Technical product information

Topic	Squeaking noise from the footwell whilst steering / manoeuvring at low speed
Market area	Australia E04 Bentley rest Asia and Australia (6E04),China 796 VW Import Comp. Ltd (Vico), Beijing (6796),Germany E02 Bentley rest Europe (6E02),Japan E03 Bentley Japan (6E03),Korea, (South) E08 Bentley South Korea (6E08),United Arab Emirates E06 Bentley Middle East and Africa (6E06),United Kingdom E01 Bentley UK (6E01),United States E05 Bentley USA and rest America (6E05)
Brand	Bentley
Transaction No.	2073002/1
Level	EH
Status	Approval
Release date

Bentayga Series

Figure 4

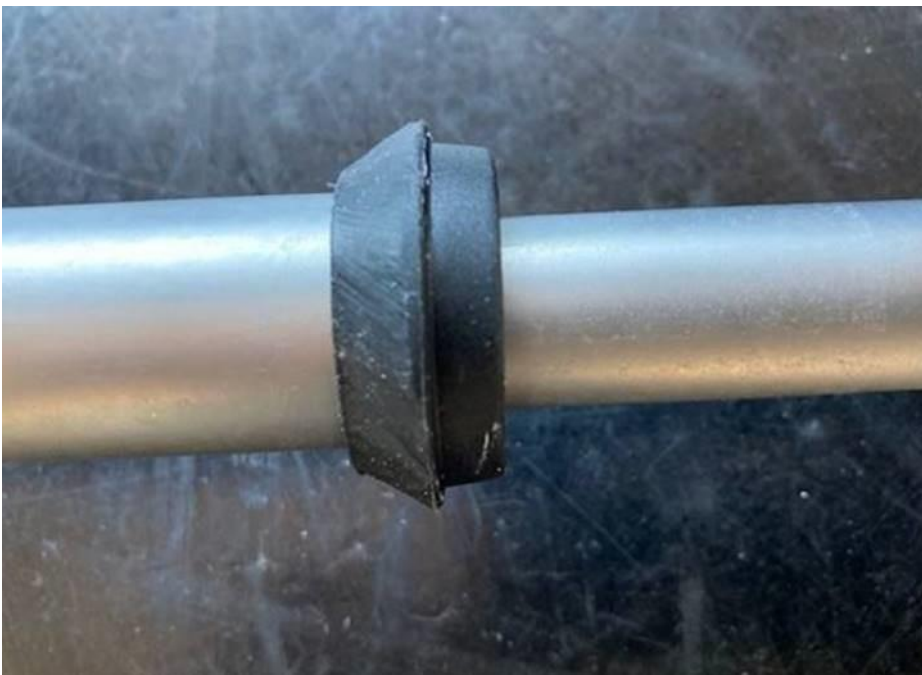
2) Using a suitable knife cut (shape) the intermediate steering shaft rubber collar on the sleeve side at a 45° angle (Figure 3) until at the condition is as shown in Figure 4

Warning: Do Not slide the rubber collar on the shaft

Only the sealing boot may be moved on the shaft
